SUBJECT: **Safety Tipping Point Overloaded:**
"Sight Distance Study" & Proposed Plat
for "5th Street Bluffs Subdivision"

RE: PROPOSED "5TH STREET

BLUFFS SUBDIVISION"

FROM ORIGINAL "GRANDVIEW HEIGHTS" SUBDIVISION PLAT OF RECORD

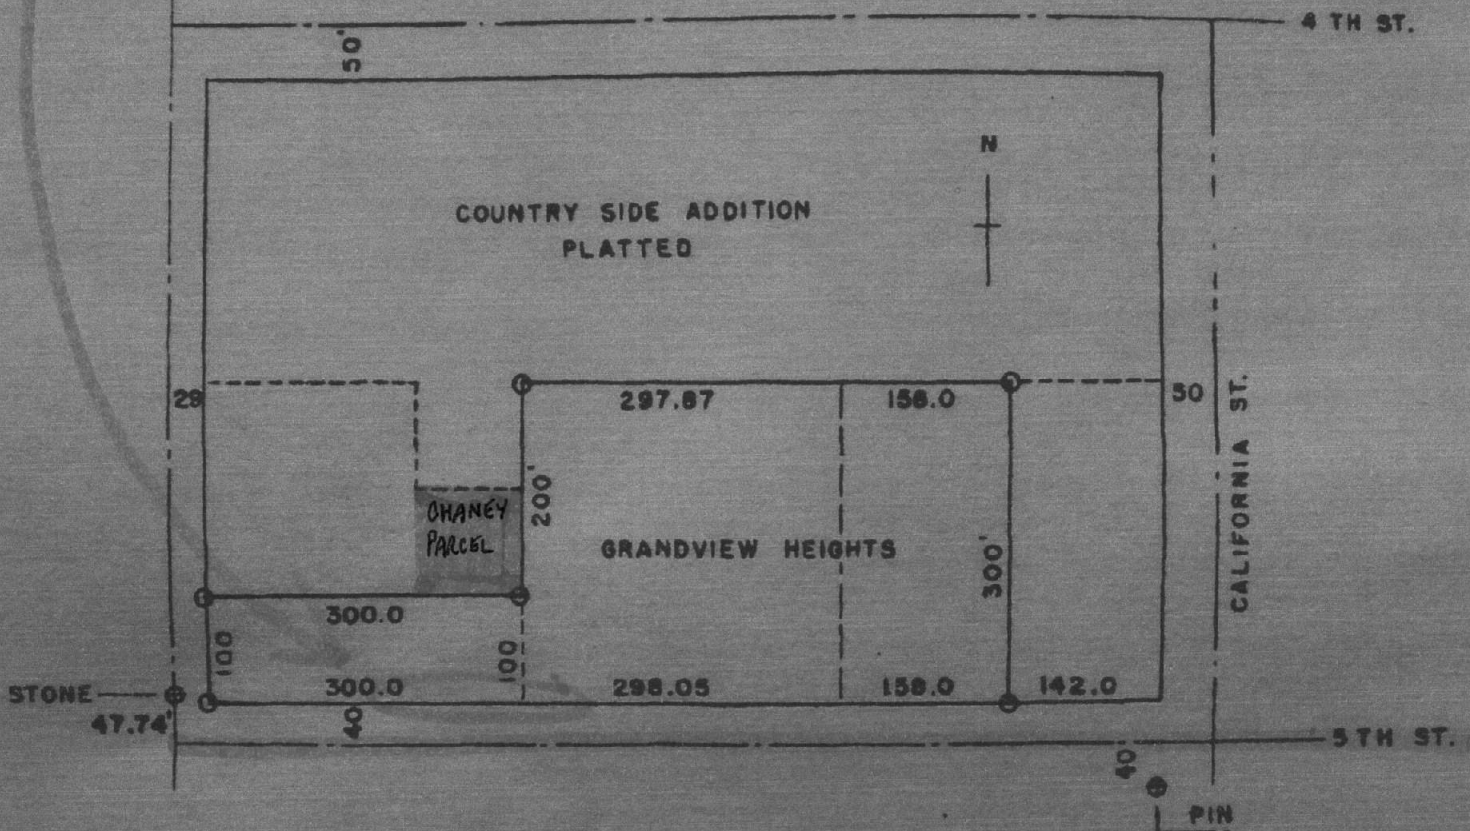
Further: The existing plat for Grandview Heights omits the subject unplatted parcel entirely from its intended neighborhood planning. No stated intent for access is indicated. Indeed, the block-form "PLATE" appearing lower left on that subdivision plat **EXCLUDES** any access point whatsoever to the subject parcel along 5th Street. This suggests that the **exclusion from 5th Street was quite intentional and made visibly explicit by safety-minded, thoughtful planners of the past.**

NO 5th St. Frontage
